APPLICATION NO.	FILING DATE	FIRST NAMED INVENTOR	ATTORNEY DOCKET NO.	CONFIRMATION NO.
09/284,117	08/14/2000	Thomas Medebach	MULL01/00028	1914
7590	01/15/2009	Liniak Berenato Longacre & Whie Suite 240 6550 Rock Spring Drive Bethesda, MD 20817	EXAMINER REDMAN, JERRY E	
			ART UNIT 3634	PAPER NUMBER
			MAIL DATE 01/15/2009	DELIVERY MODE PAPER

Office Action Summary	Application No.	Applicant(s)	
	09/284,117	MEDEBACH ET AL.	
	Examiner	Art Unit	
	Jerry Redman	3634

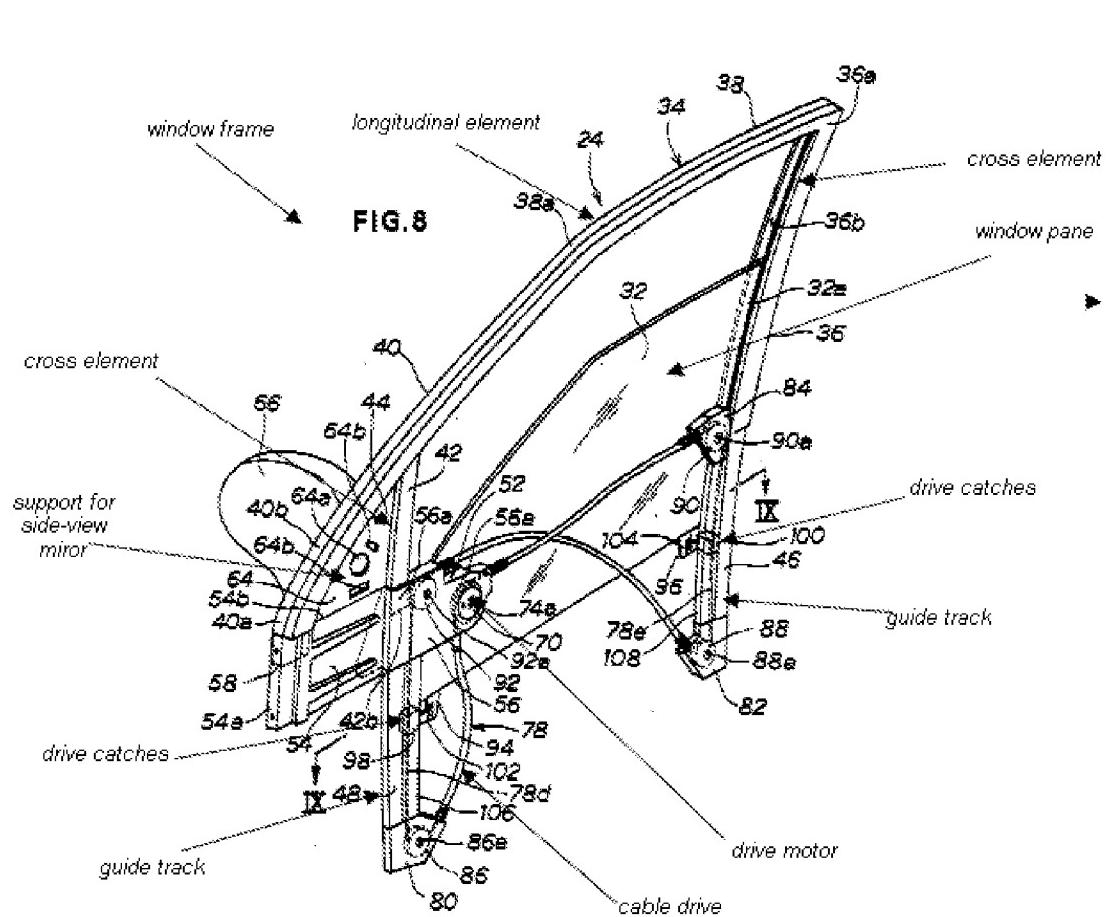
Claims 1-12 and 15-16 are rejected under 35 U.S.C. 102(e) as being anticipated by Hisano et al. (5,964,063). As shown in detail below, Hisano et al. (5,964,063) disclose a window frame and method thereof (24) for a motor vehicle door fitted with a

window lift having a drum motor (70), drive catches (94, 96), a pair of guide tracks (46 and 48), a window pane (32) being inserted within a hollow portion of the door (22', see Figure 7a, forms a box), two cross elements (42 and 36), one longitudinal element (34), wherein the window frame (24) is inserted and fitted within a hollow portion (see Figure 7a) and attached to end faces (30, best seen in figure 7a) of the door (22'). Hisano et al. (5,964,063) further disclose a Bowden cable drive (78) in the form of a figure 8, seals (see Figure 9) attached to the window frame, and a support for a side-view mirror.
